Re: Proposed windfarm development including 13 no. wind turbines in Bunnyconnellan, Co. Mayo and hydrogen plant in Castleconnor, Co. Sligo.
Carrowleagh, Bunnyconnellan, Co. Mayo and Curraun, Castleconnor, Co. Sligo.

Áine McCann. BSc (Hon) Environmental Science

Mercury Renewables to An Bord Pleanála Dated November 2023 Regarding Application No; ABP-317560-23 (PA16.317560).

Windfarm and Hydrogen plant. Sligo/Mayo.

Figure 3.1. Borehole 6 pumping test data

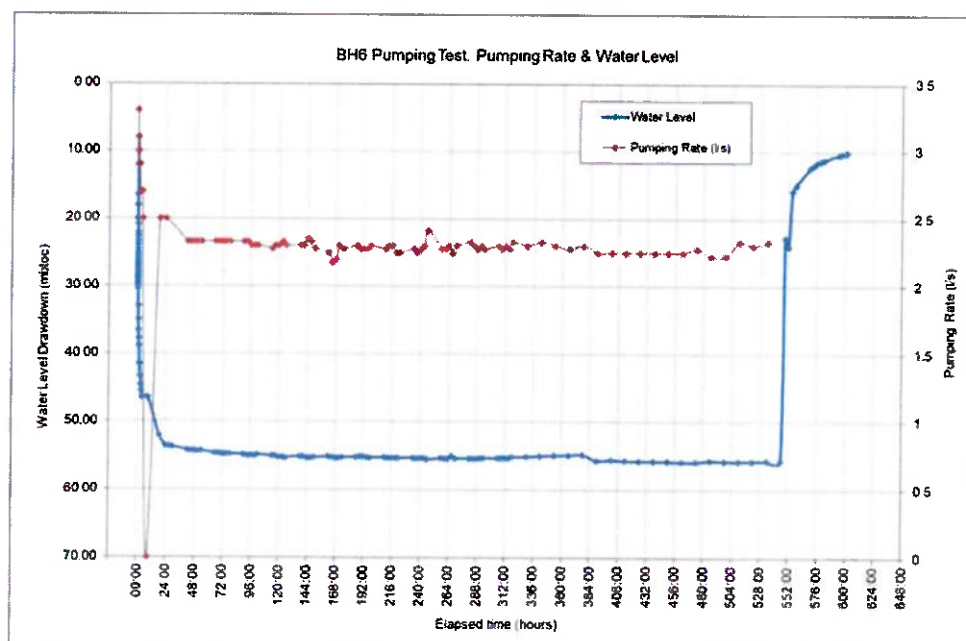
If we look at Minerex the graph of BH6, the productive well, based on the curve of the graph this aquifer suggests it can be one of three aquifer types: a confined aquifer, a leaky aquifer, or a recharge boundary.

Minerex have not defined which type it is and the implications of this clear for long term pumping. This is of importance in relation to recharge as we are also not aware if we are dealing with an aquitard or an aquiclude.

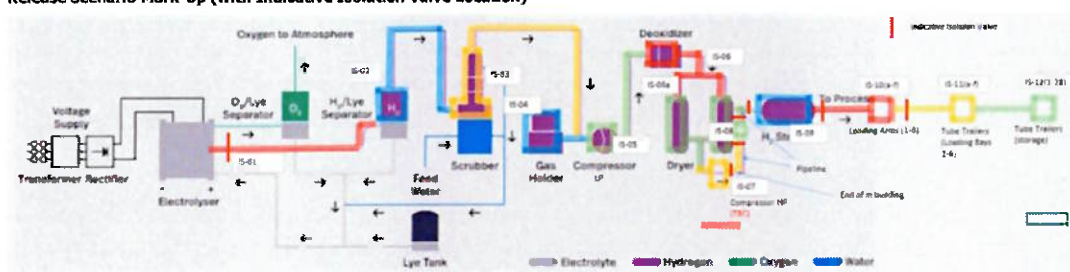
This is of significant importance in relation to Health & Safety issues during production as a figure of 40 metric tonnes has been given as the maximum amount of H₂ gas that will be held on site at any one time. There is however some confusion and inaccuracies over this figure through the documentation.

However, and most importantly the figure of 40 metric tonnes does not include any H_2 gas that will be in the production equipment during operational phase (to include all machinery, piping leading to and from production equipment as well as to all storage vessels and distribution areas).

There is a possibility that this figure could amount to another 1000kg bringing this proposed facility into the tier 1 COMAH sphere.

Figure 2 Hydrogen Plant Plan*

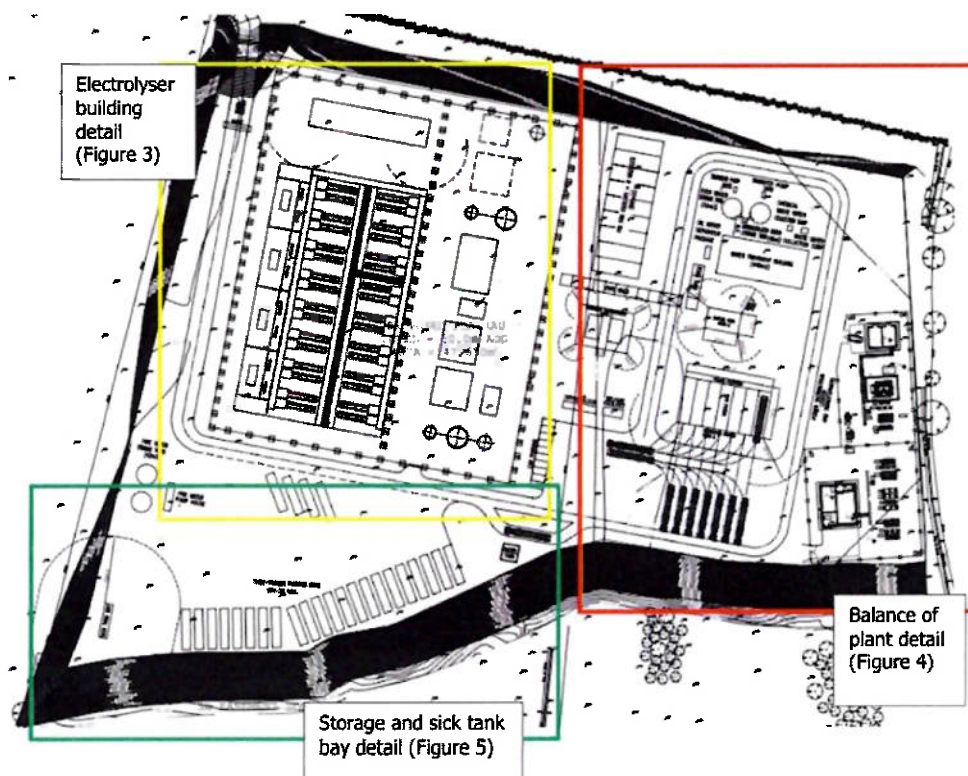
*Note the original analysis was carried out on an earlier version of the plant layout, however the layout shown here is similar and so the findings in this report remain valid.

Figure 3 Electrolyser Building Detail

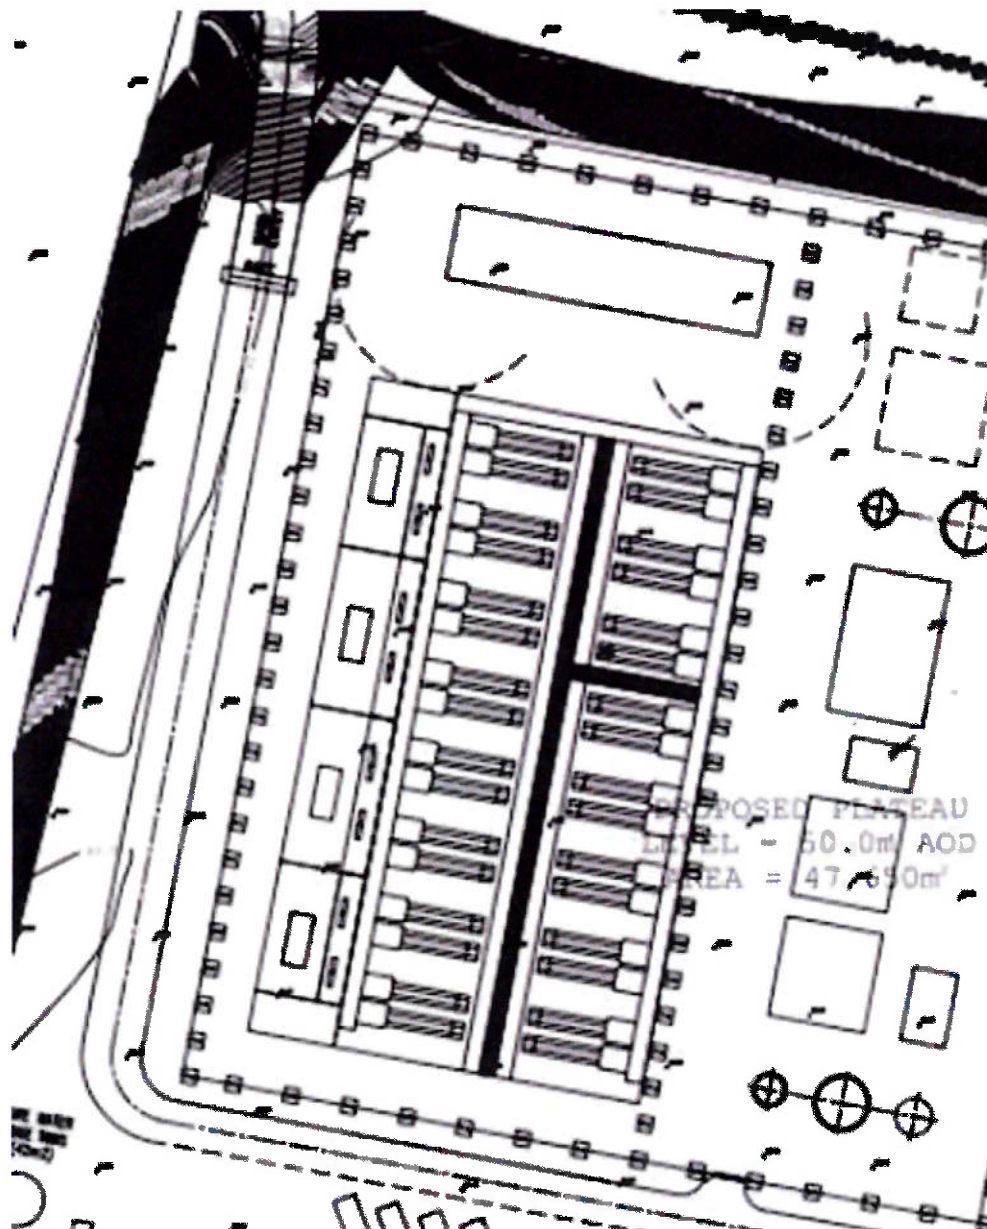
No pipework shown in diagram between electrolyzers or to storage area for H₂ gas.
Compression of H₂ gas to 500bar is a stepwise process requiring more pipework.

Figure 4 Balance of Plant Detail

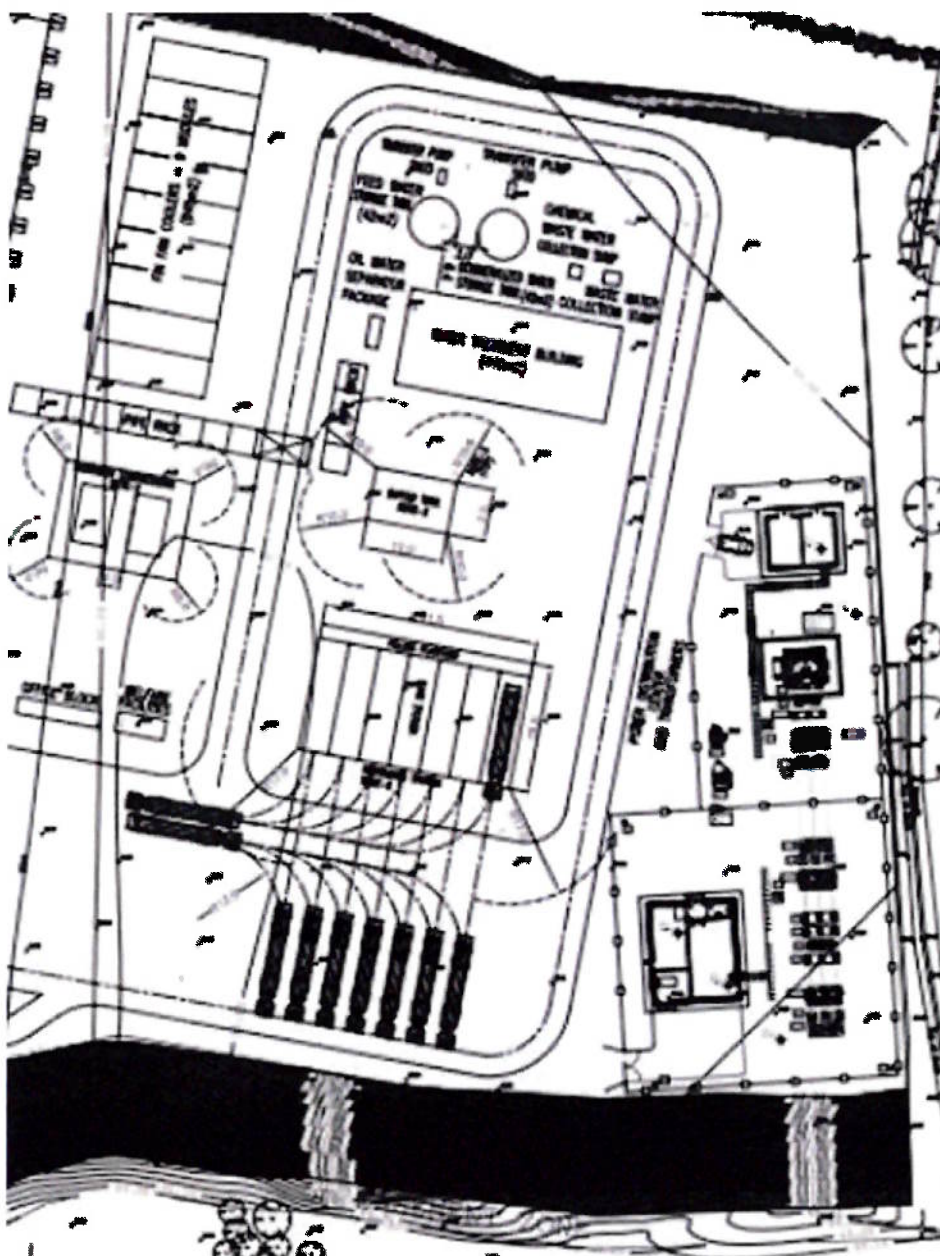
Only pipework to HGV's shown here

Figure 5 Storage and sick tank bay detail

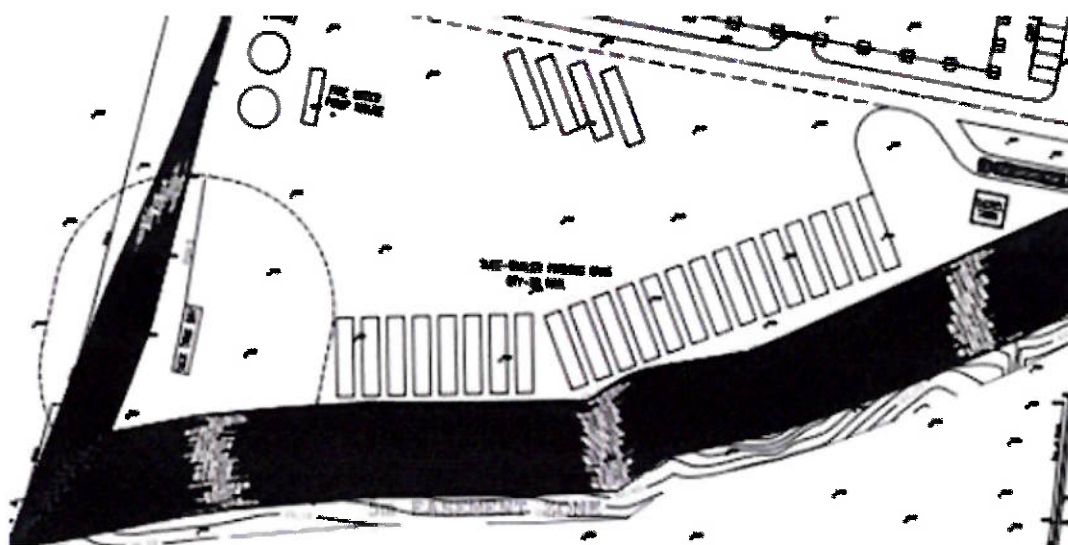
Resting and/or damaged filled/part filled tube trailers can rest here before retrieval.
